Product Change Notification

1. ECR #: 168943
Notification #: 408

- TSM - .025 SQ. TERMINAL STRIPS

4. Part #'s Affected

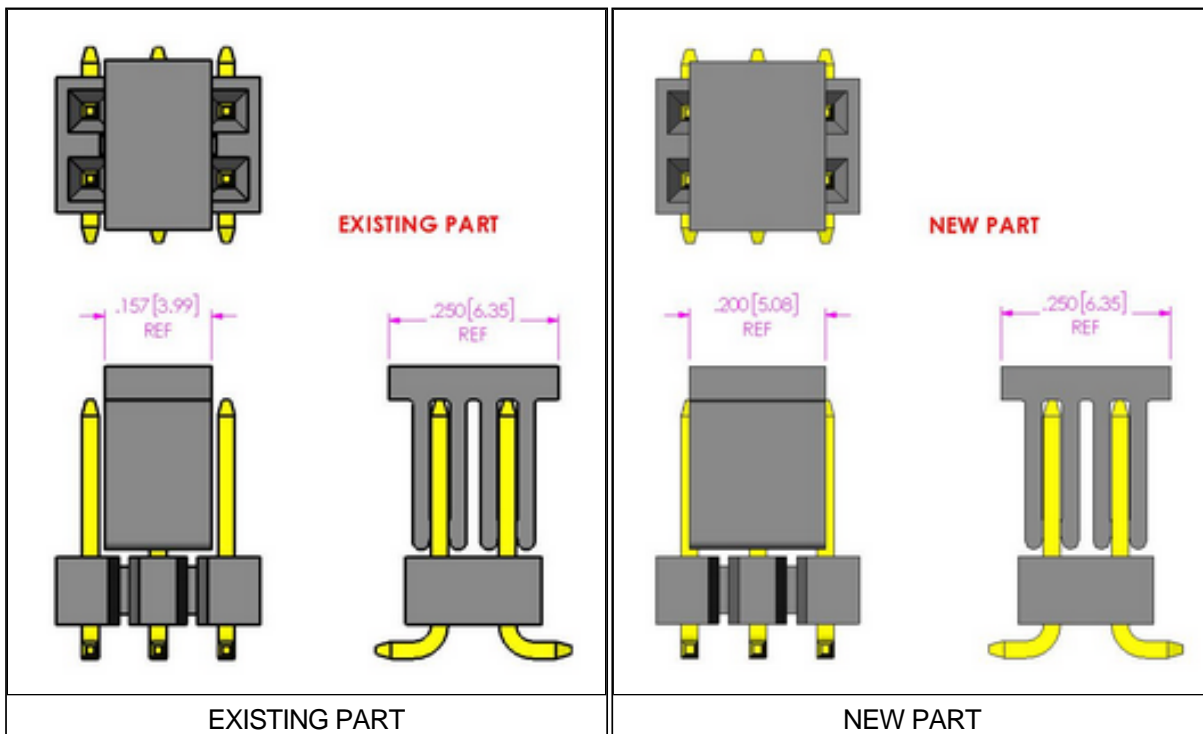
Change the 03 position connector pick and place pad from .157x.250 to .200x.250

New pad is .200" long where as old pad was .157" long. Both old and new pad have the same width at .250"

Change is being made to improve pick and place pad placement. The change is being made for -P option for -03 position with -TR packaging.

- Form - Pick and place pad option---03 position will use new pick and place pad. This is a rolling
